From: Jolynn Franke <jolynn.franke@cherriots.org>
Sent: Tuesday, March 7, 2023 10:21 AM
To: Jamie Donaldson
Subject: Comments for Case No. SUB-UGA-SPR-ADJ-TRV-DR23-02
Attachments: SUB-UGA-SPR-ADJ-TRV-DR23-02_2100 Block of Doaks Ferry Rd NW.pdf

CASE/APP NUMBER: SUB-UGA-SPR-ADJ-TRV-DR23-02

PROPERTY LOCATION: 2100 Block of Doaks Ferry Road NW

REGARDING: Subdivision Tentative Plan, Urban Growth Preliminary Declaration, Class 3 Site Plan Review, Class 2 Adjustment, Tree Variance, and Class 1 Design Review Case No. SUB-UGA-SPR-ADJ-TRV-DR23-02

The graphic below is an enlarged segment of the applicant's drawing **SDR8** at the intersection of Parcels 5 and 6 and Doaks Ferry Road.

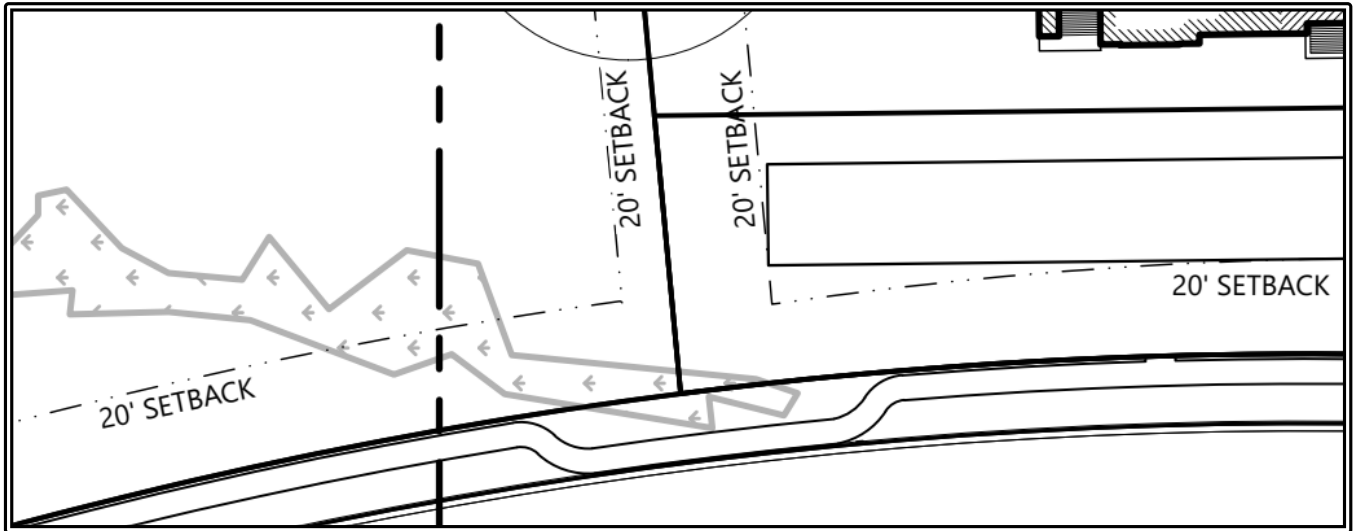
1. Why is the Parcel 6 setback distance of 20' from Parcel 5 not identical to the other 20' setbacks?
2. Why is there no identification or labeling of the 75-foot riparian setback from Wilark Brook?

Final SDR3 southeast segment

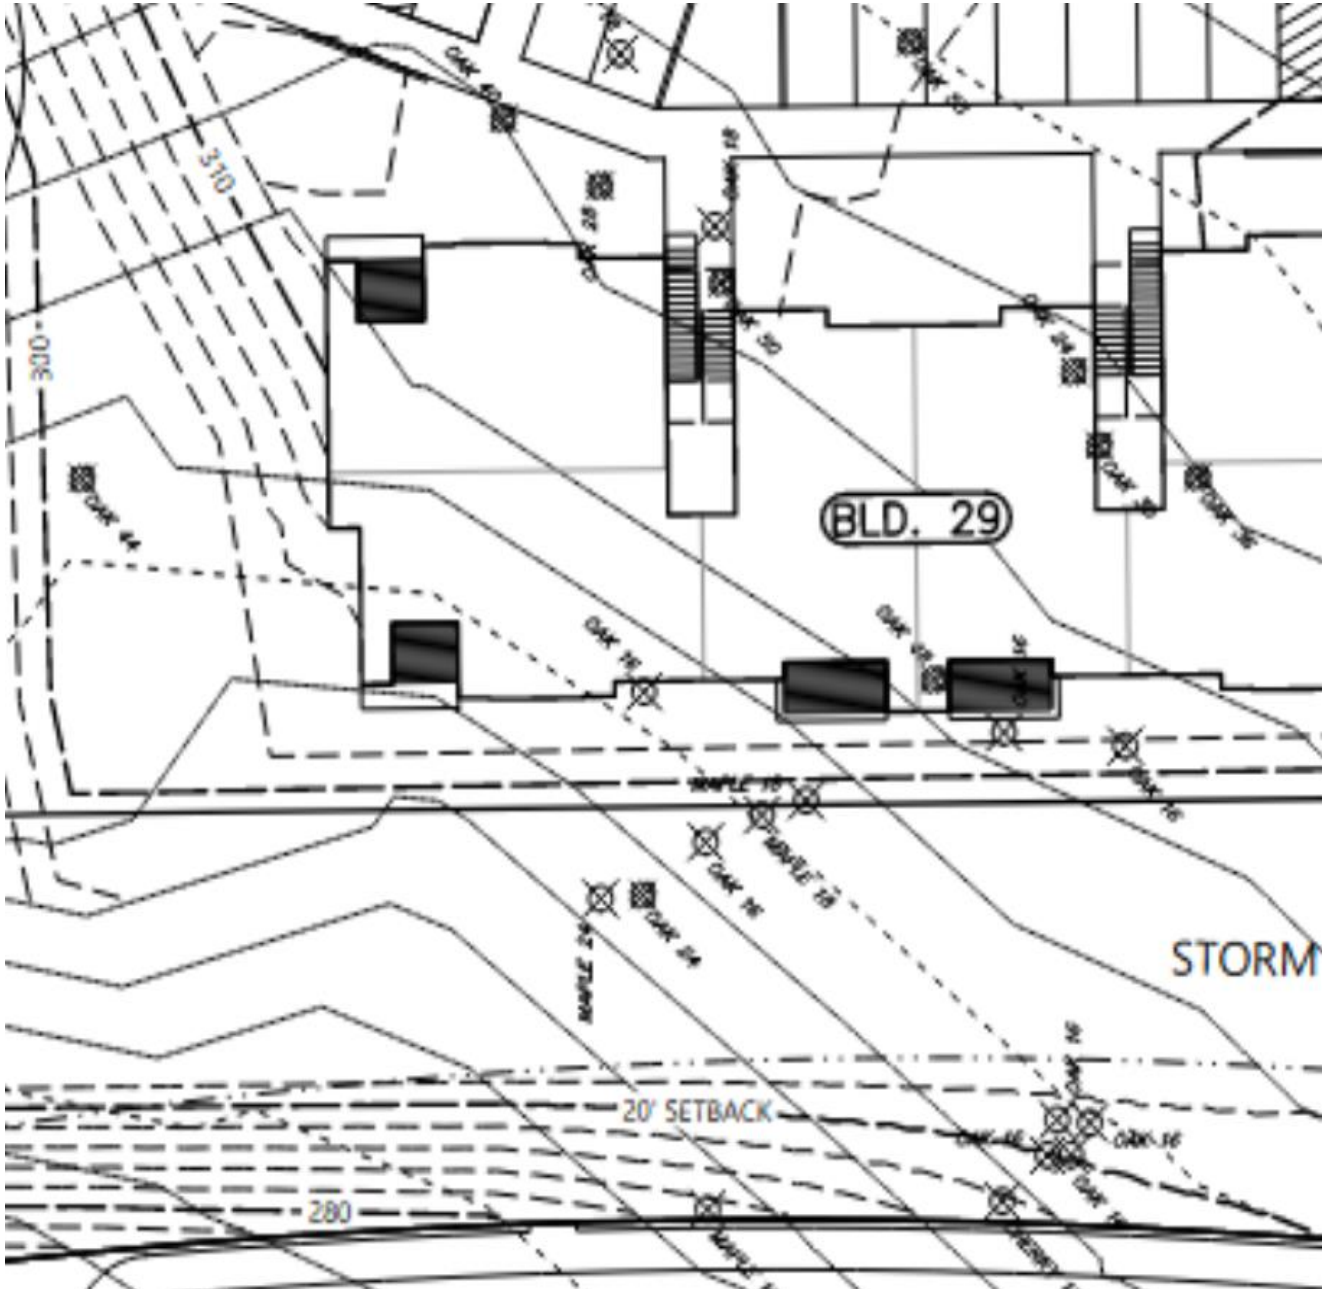
Why are the significant white oaks trees to be removed not numbered as they are on the preliminary **SDR3** sheet segment shown on the next page and cataloged on the applicant's tree variance request sheet?
